**From:** [Robert Story](#)  
**Sent:** Wednesday, 24 January 2024 4:34 PM  
**To:** [council@northernbeaches.nsw.gov.au](mailto:council@northernbeaches.nsw.gov.au)  
**Subject:** 5 Portions DP 590990 Lovett Bay - DA 2023/1832 Submission against approval

## **OBJECTIONS AND COMMENTS ON DA 2023/1832**

### **5 PORTIONS, LOVETT BAY NSW**

DRG-03  
TOWER LOOK OVER DUNCAN  
HOUSE

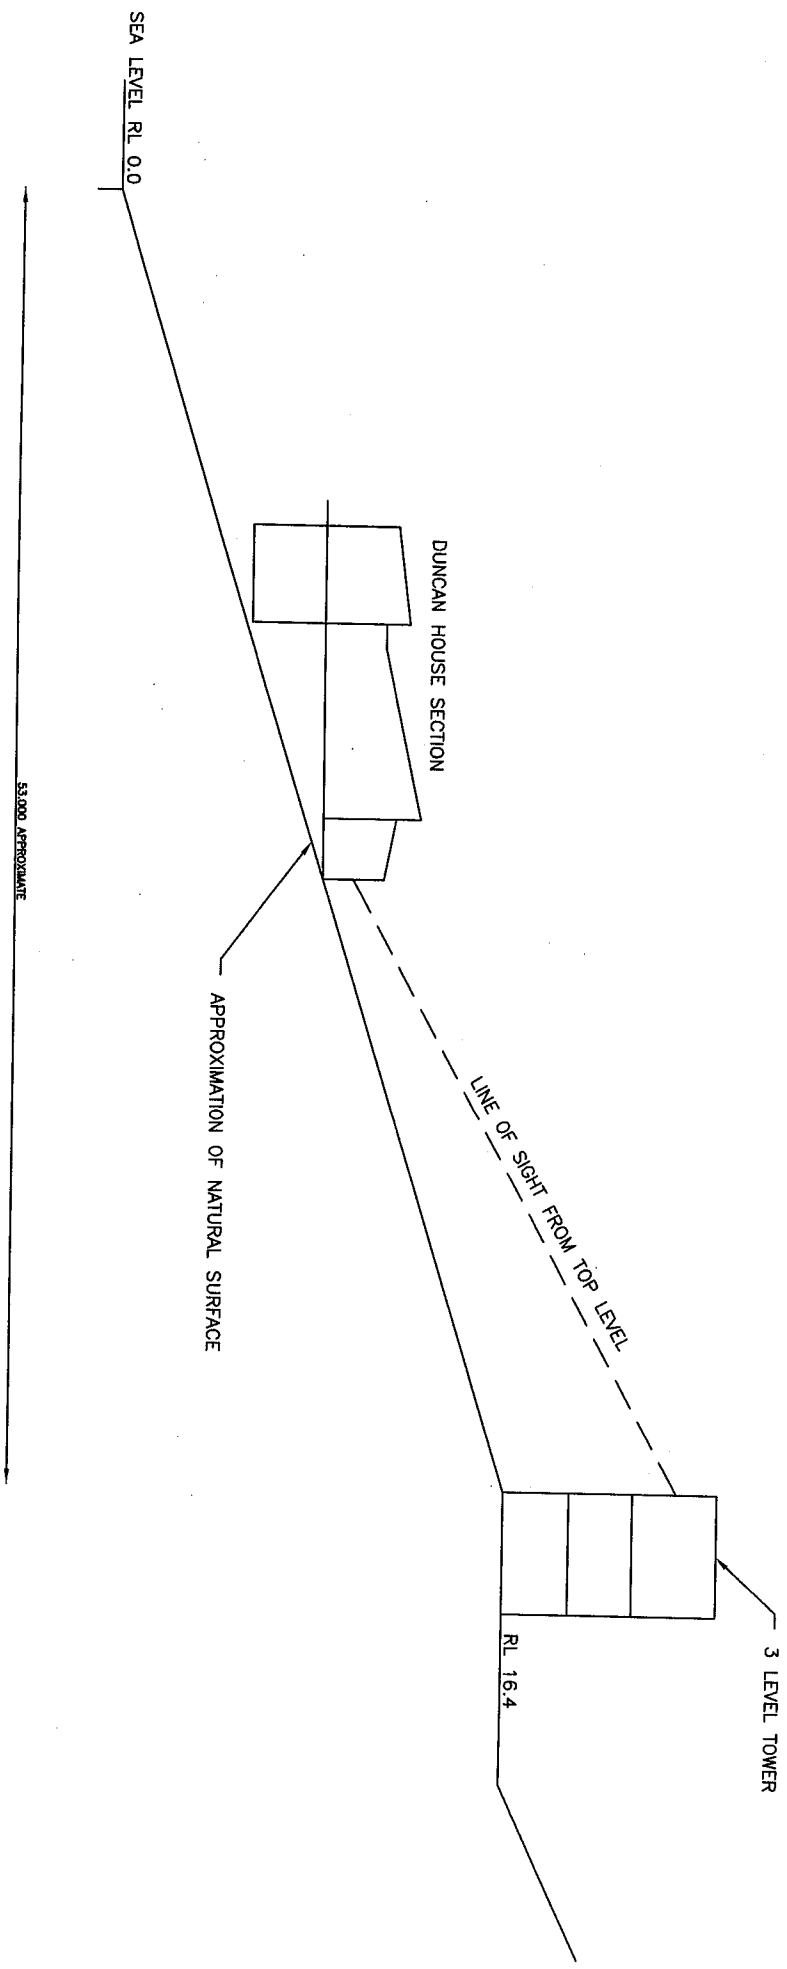
3. 5 Portions site is subject to high moisture content especially in heavy rains resulting in intermittent and semi-permanent springs.
4. Geotech report misrepresents the steepness of the site and the problems with water run-off.
5. Shadow lines are grossly understated and need to be reinvestigated. The shadow of the house would come to the back door of 3 Portions, which means that main building and the tower would dominate the view from that position.

DRG-04  
ACTUAL SLOPE

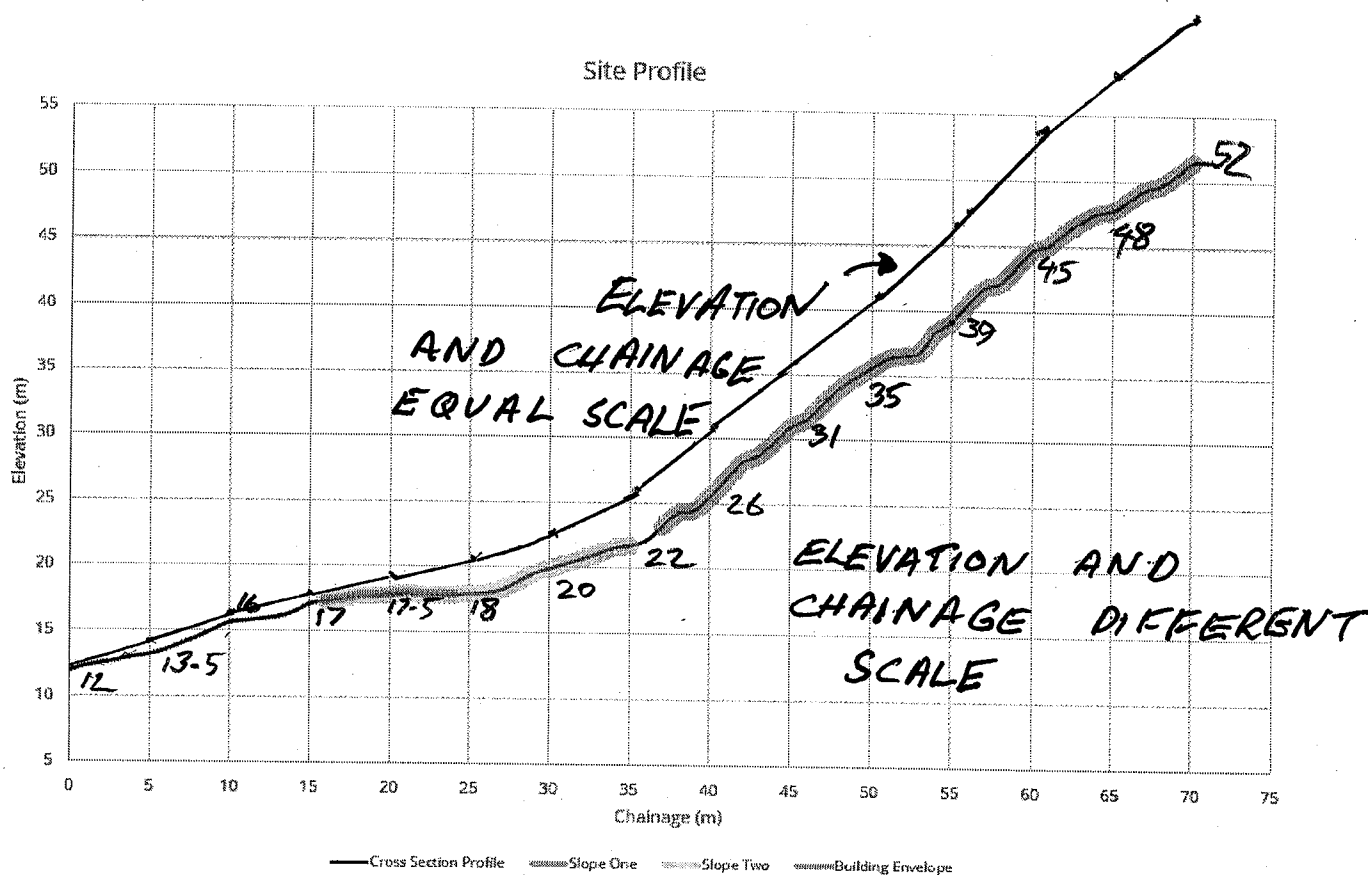
**Figure 3.1** profile cross-section is misleading. The elevation and chainage are different scales, giving a shallower appearance of the slope of the land.

Refer to DRG-04 The block is steeply sloping from the water's edge, starting at 20 degrees and increasing to 45 degrees.

There are several horizontal benches or terraces cut into this slope but they do not affect the overall steepness of the block.

DRG-05 BOUNDARY ERROR  
APPENDIX A

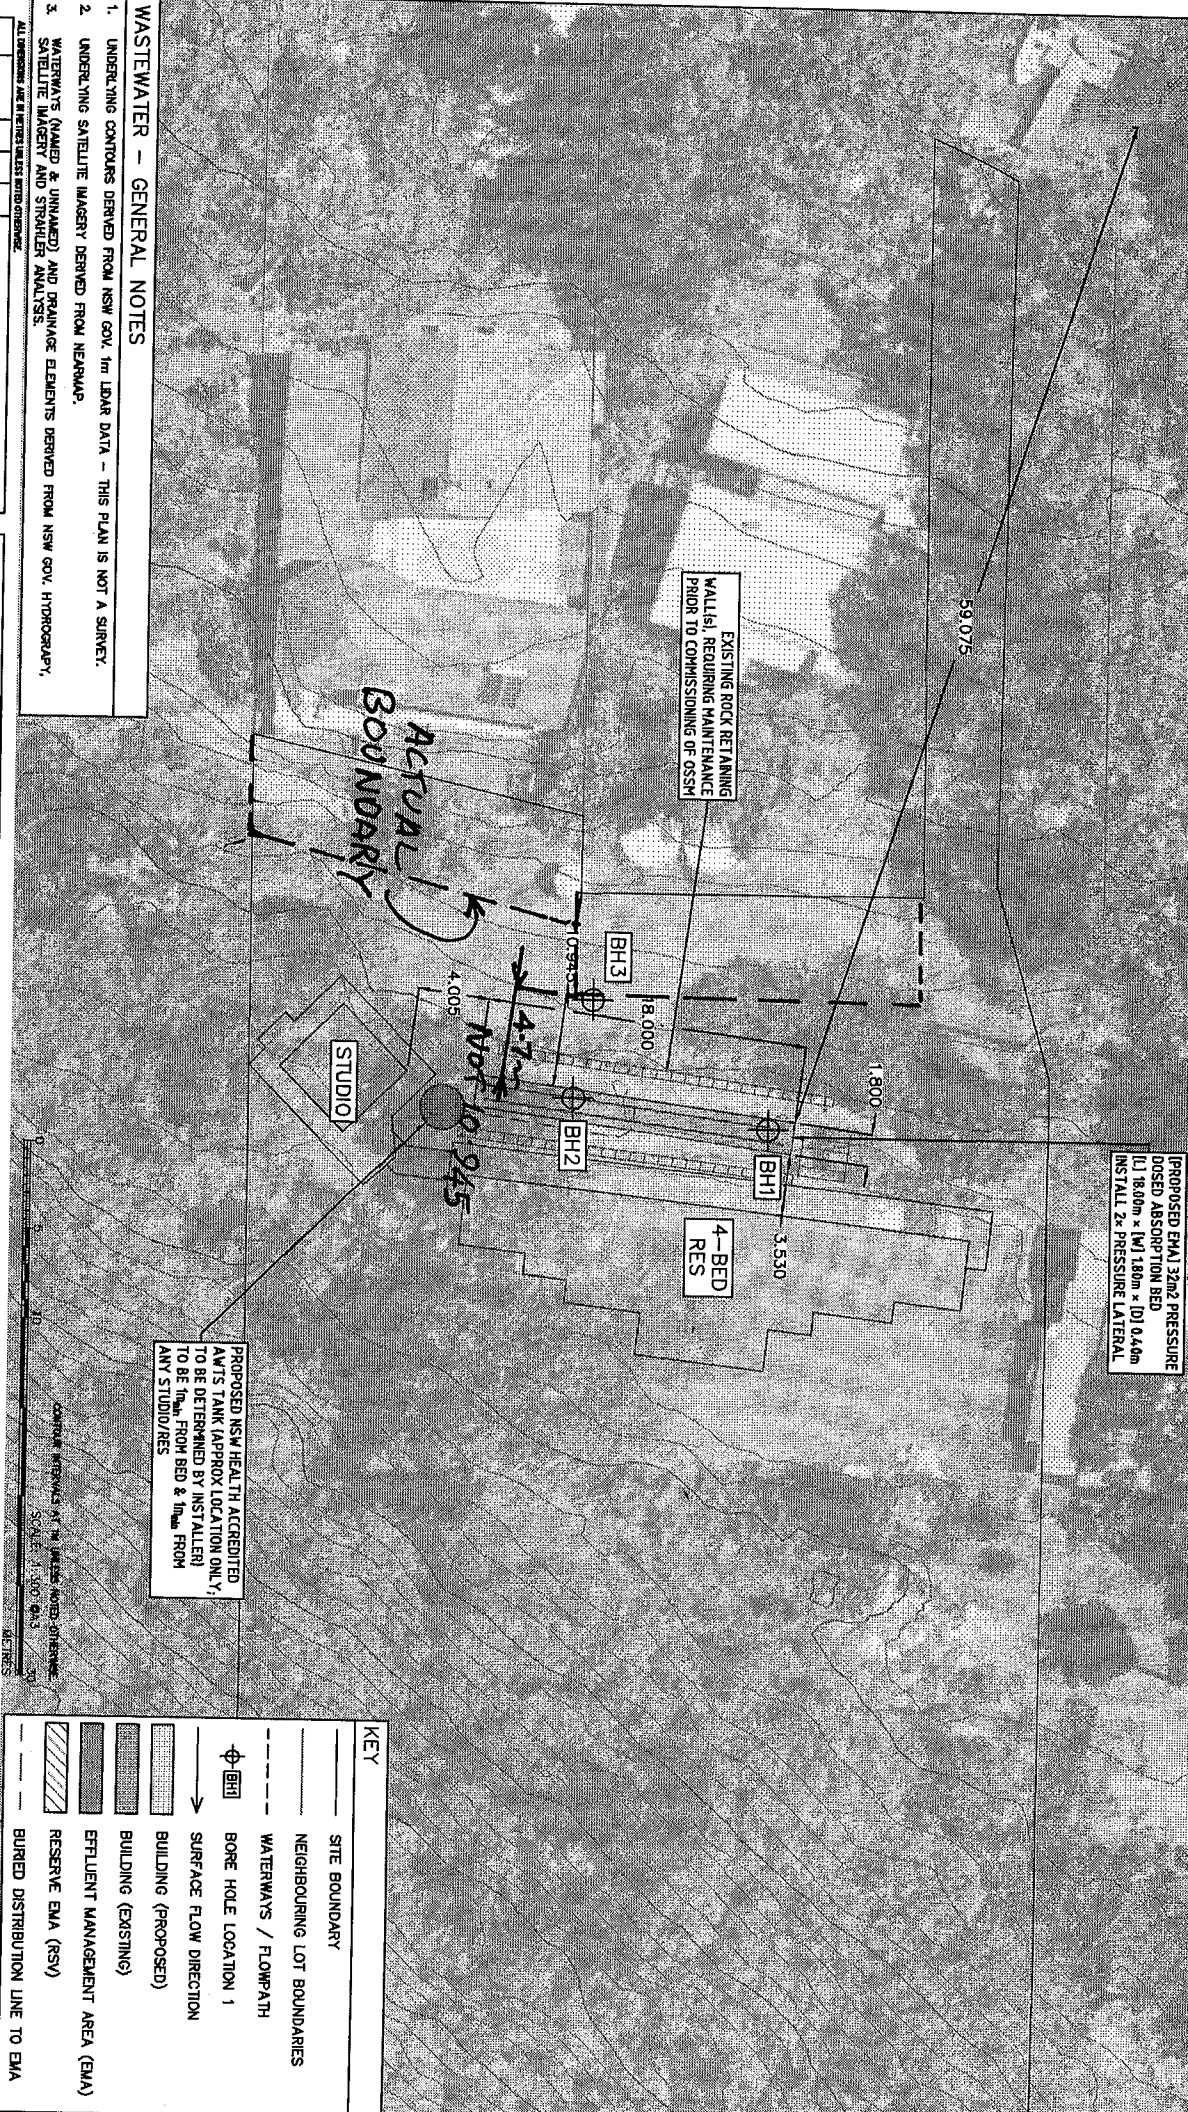
**Appendix 1: Boundaries of Lot 3 and Lot 6 incorrectly drawn and show a major discrepancy of 7 meters. See drawings 5 & 6.**

1. EMA is far too close to 3 Portions boundary and must be located at least 12 meters off this boundary.
2. Appendix 1 of the wastewater report shows the Portion 3 property boundary to be approximately 7 metres south of the actual location.

DRG-07 SHADOW LINE

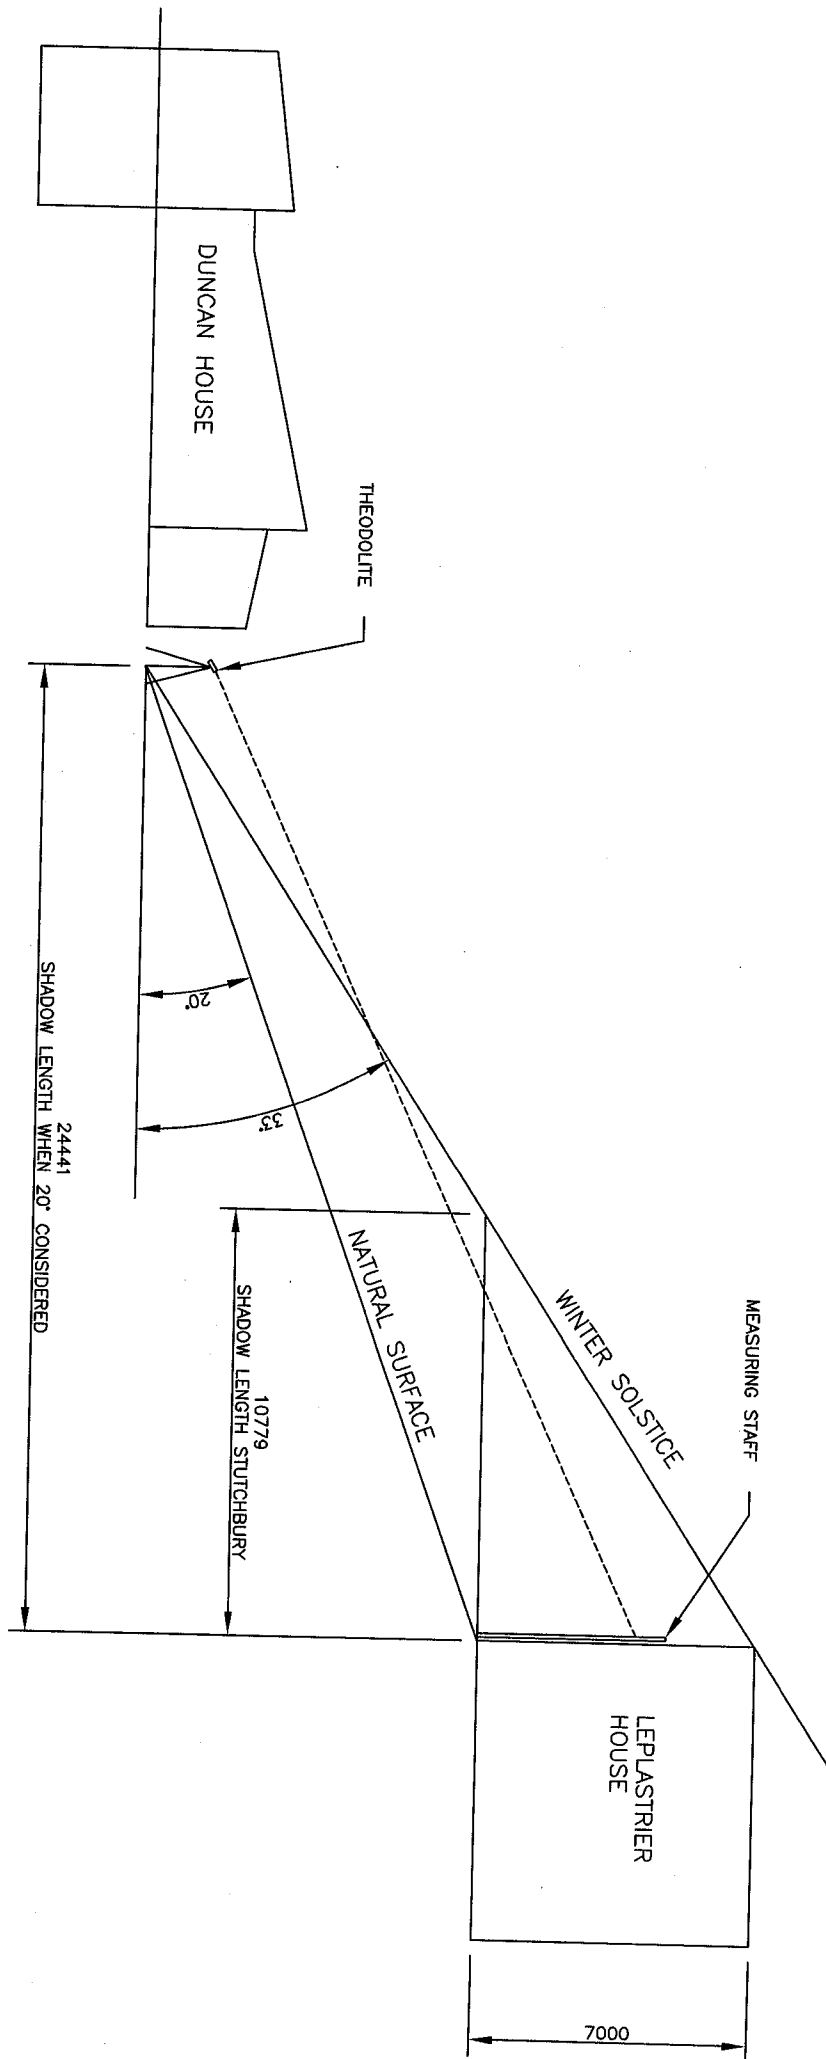
Analysis does not take into account that the land between 5 Portions and 3 Portions, falls steeply away at around 20 degrees. The shadow lines chase the sloping land until the shadow line catches up. Shadow length is around 11 metres, whereas I have calculated a shadow of approximately 25 metres. **See DRG 07.**

We can argue the correct shadow length, but the simplest solution is to carry out a site measurement. A theodolite can be set up at the Duncan House to sight a measuring staff at the Leplastrier designed building at the front elevation. Knowing the distance and the angle, an accurate drawing can be compiled. **See DRG -07.** No surveyor is required as I have a theodolite and can do a full and accurate check with a representative of the Leplastrier family.

DRG-08

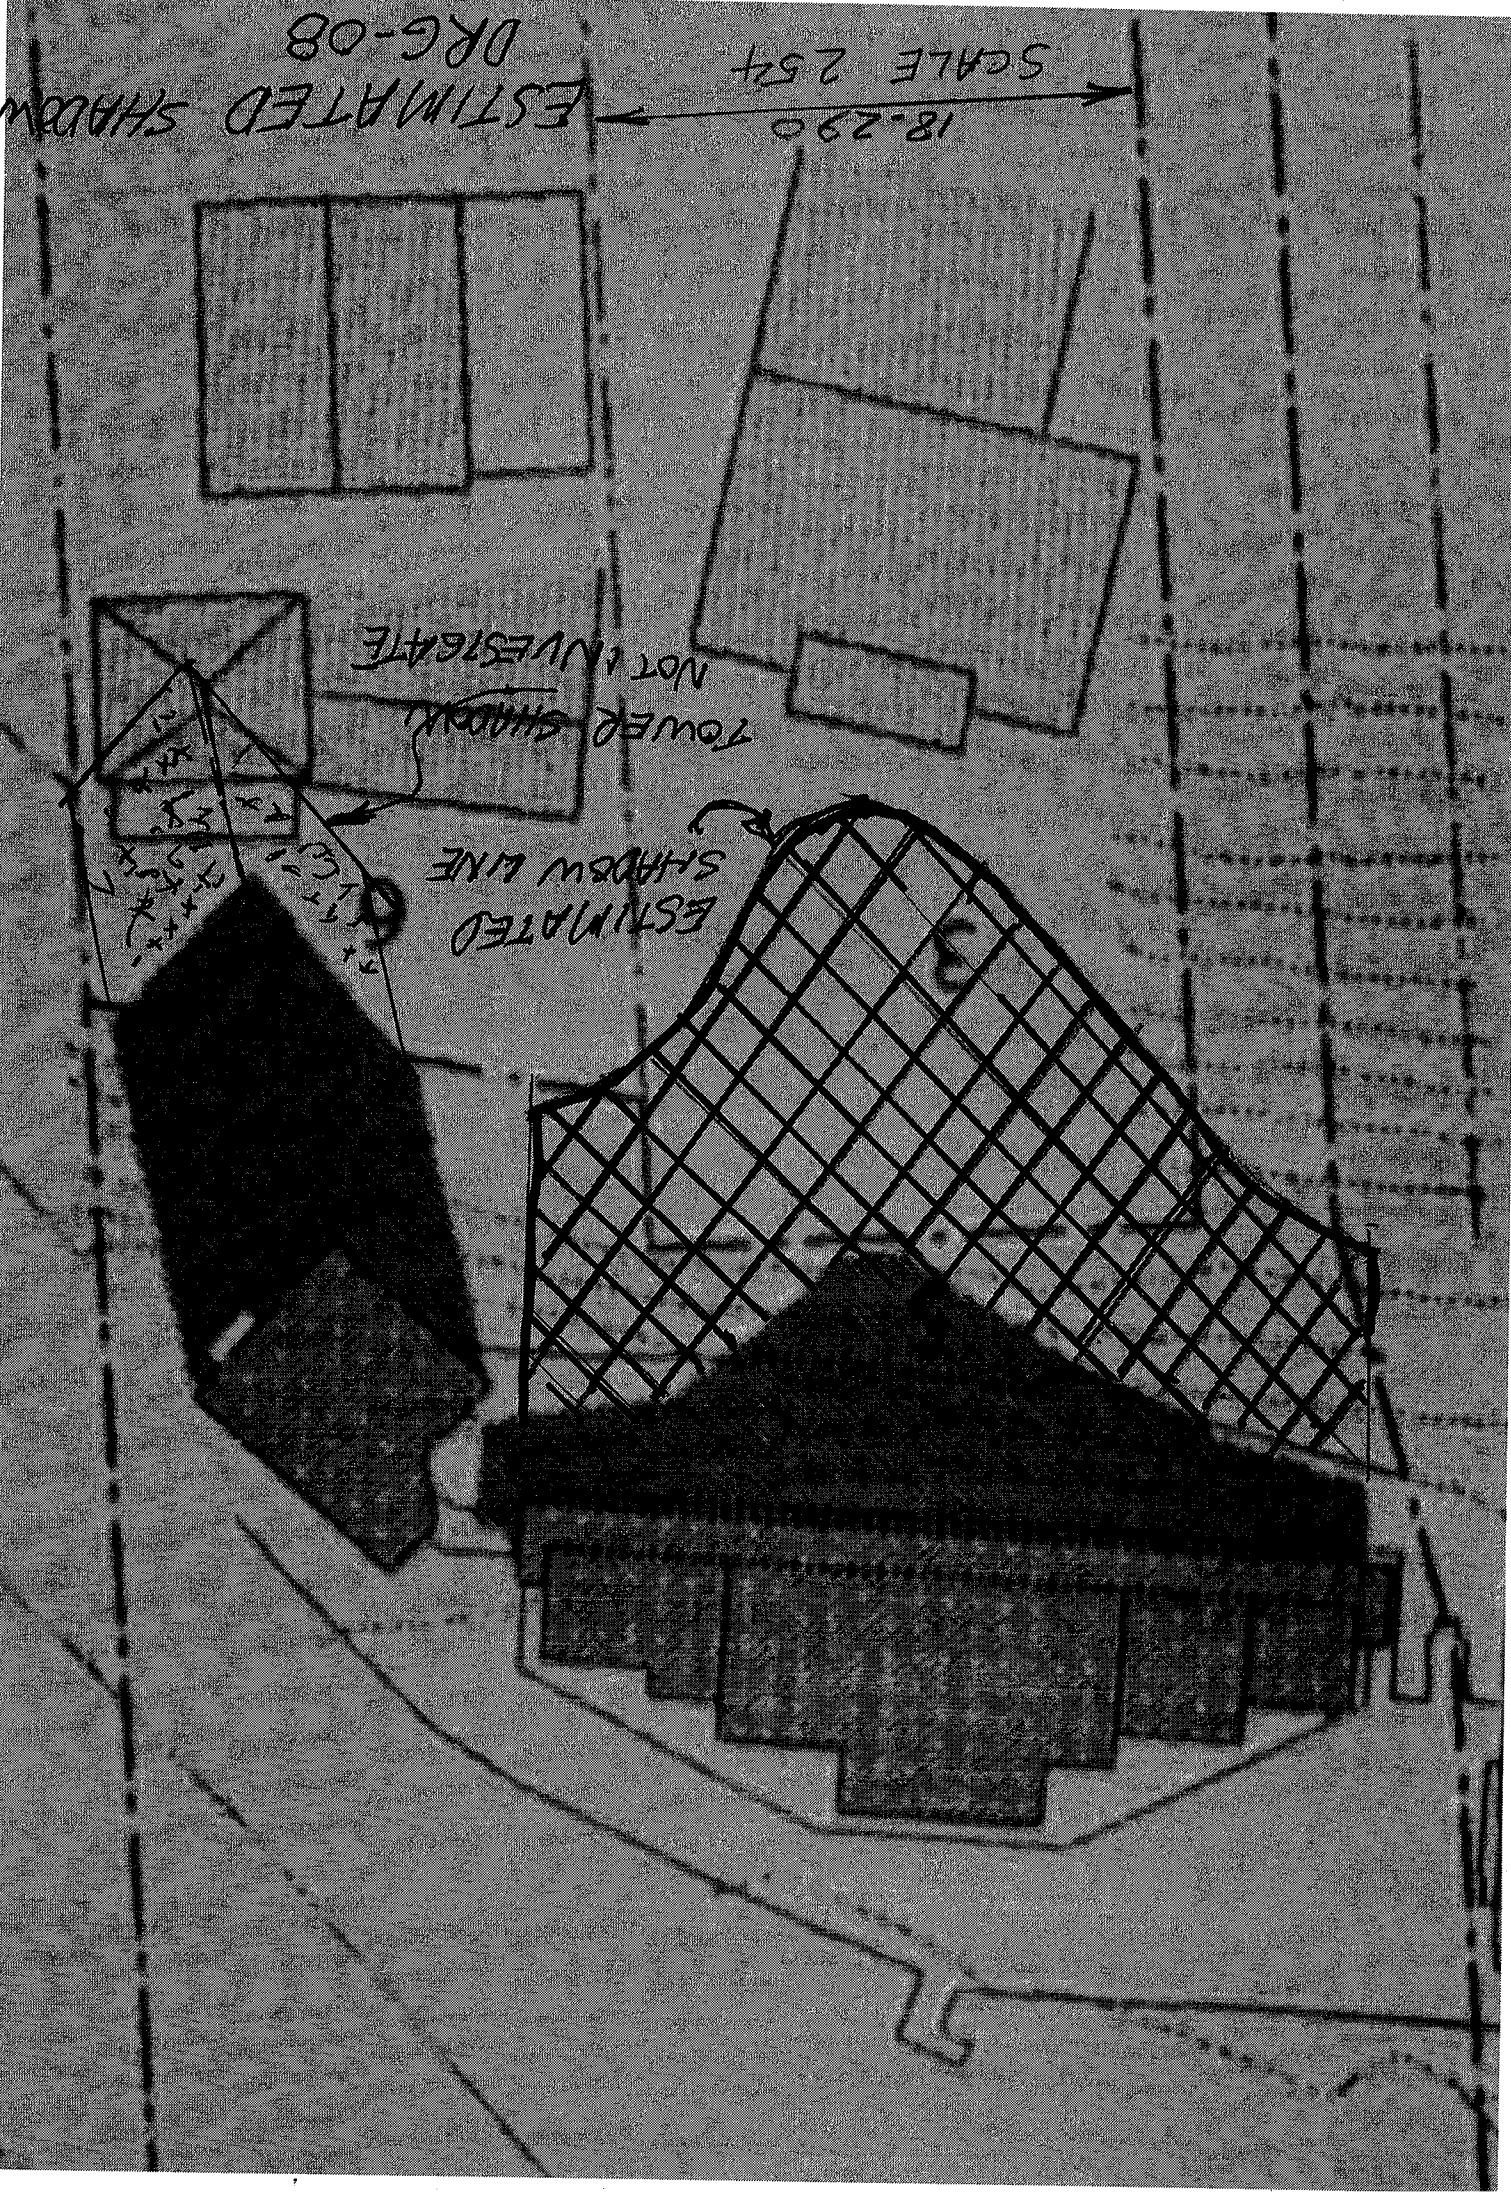
There is a fundamental error in the shadow lines provided. *See DRG 01, 07,08.*

If my analysis of the above is correct, a similar check for accuracy should be done on the proposed tower where the shadow will fall onto 6 Portions.
